UNITED STATES PATENT AND TRADEMARK OFFICE

APPLICATION NO.	FILING DATE	FIRST NAMED INVENTOR	ATTORNEY DOCKET NO.	CONFIRMATION NO.
09/719,138	02/08/2001	Hirokazu Fujino	0020-4783P	5320

Office Action Summary

DETAILED ACTION

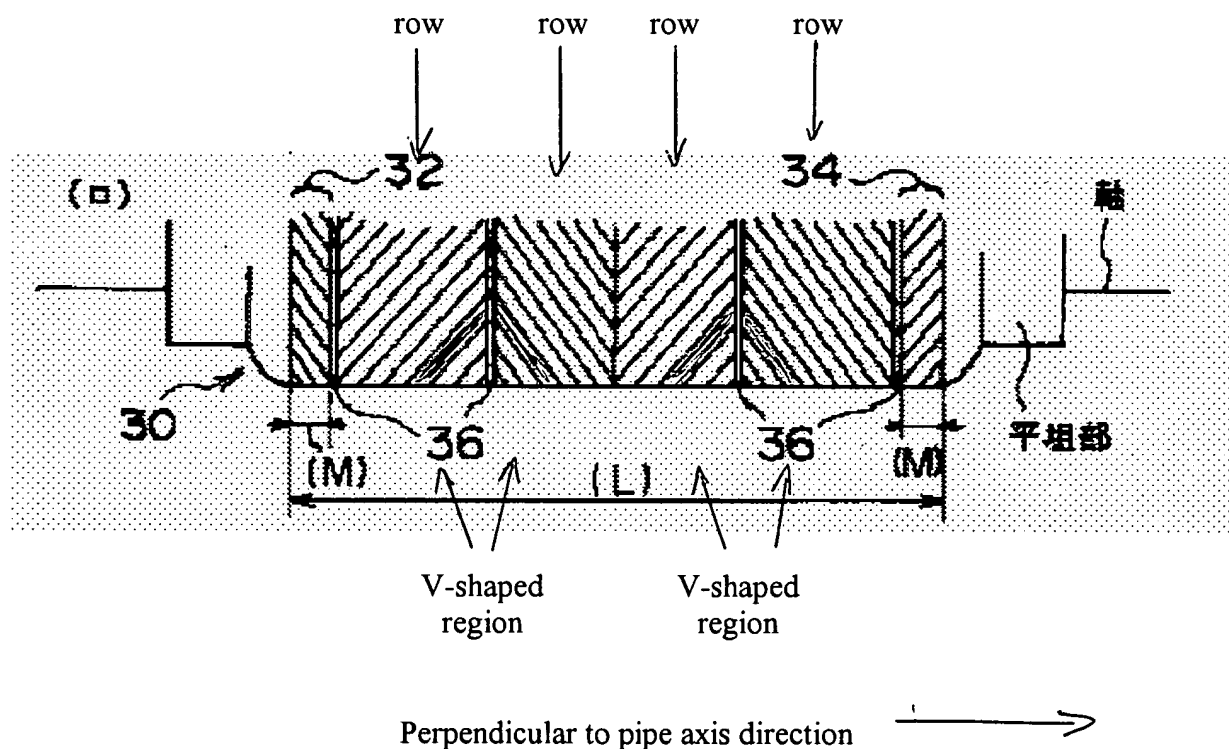
The rejection under 35 USC 112, first paragraph is maintained. While the claims concur with the drawings and a portion of the specification, the other portion refers to the term "symmetric."

Figure 1 of Yamamoto et al discloses a device and method for manufacturing a heat-transfer pipe with internal grooves comprising a first marking roll 30 forming first and second rows of parallel grooves (in red) to forming a series of V-shaped regions (in red, Figure 2 below) repeating along a line on the inner surface perpendicular to the pipe axis direction. Further, the width of the two rows of parallel grooves is different.
